**STAFF REPORT: AUGUST 9, 2023 MEETING**

**APPLICATION NUMBER: 23-8404**

**ADDRESS: 8022 KERCHEVAL**

**SCOPE: WINDOW REPLACEMENT ON SIDE AND REAR ELEVATIONS**

Applicant drawing

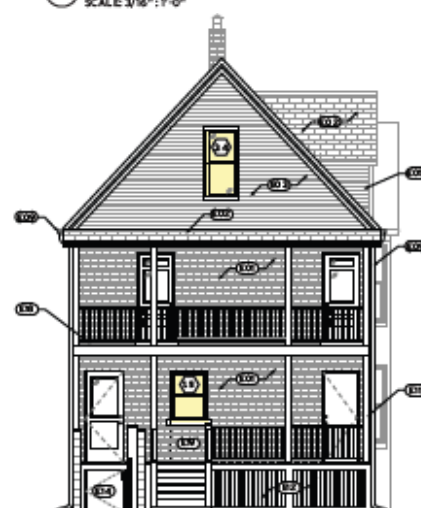
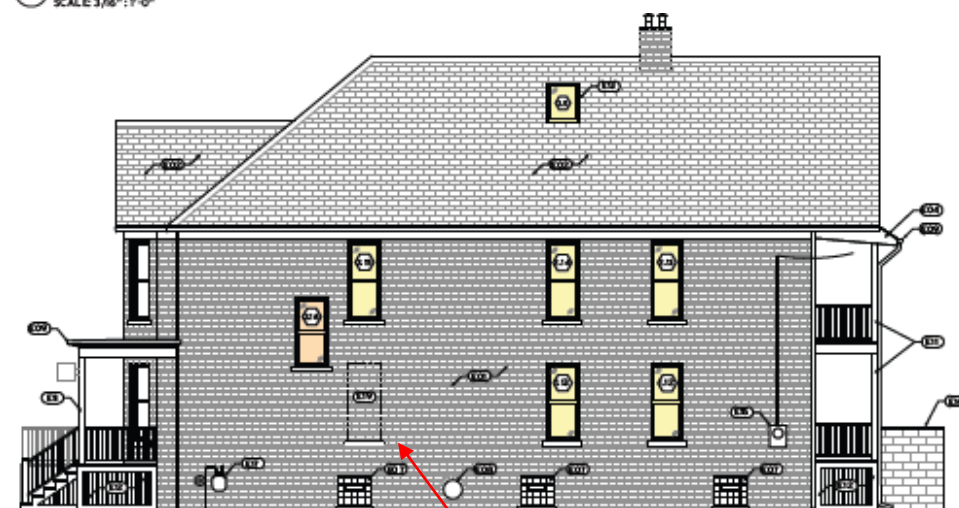
- The elevation includes two window openings; one new opening and one historic opening in the gable (which is proposed for replacement).

- The window openings are minimally visible from the right-of-way- due to the proximity of the adjacent property.
- *The window openings at the second floor are each missing the lower sash.*
- The applicant intends to retain and repair the window sash in the opening that is halfway between the first and second floor.
- The first-floor window opening closest to Kercheval is intended to be bricked-in; the specification calls for brick to be placed flush with the exterior masonry wall.

- It remains staff's opinion, the wood windows, due their deep setting within the openings, and exceptionally detailed brickmold, are distinctive character-defining features of this property.

- Staff notes that both repair quotes include the specification that the windows will receive full restoration. It is staff's opinion that full restoration would likely return the windows to look and function like they did when they were first installed, which is more expensive than the cost would be to make the windows operable and functional (which is equal to Level Two Rehabilitation). Each quote also includes the price of storm windows.

- Based on the memo submitted by Commissioners Hamilton and Chinchilla, it remains staff's opinion that the windows on this commercial building are repairable and should be retained.

- Staff noticed that a metal blade sign is shown on the drawings but is not part of this application. A sign proposal, that includes all details of fabrication, illumination, and installation, must be submitted as a separate application to HDC staff. This inclusion must be removed from the drawings, when submitted for permit.

- Should the west elevation window be infilled, then the brick should be recessed slightly (approximately one inch) from the exterior edge of the masonry wall so that a shadow line of the existing opening remains within this wall.

- The brick will be recessed approximately one inch from the face of the exterior masonry wall.
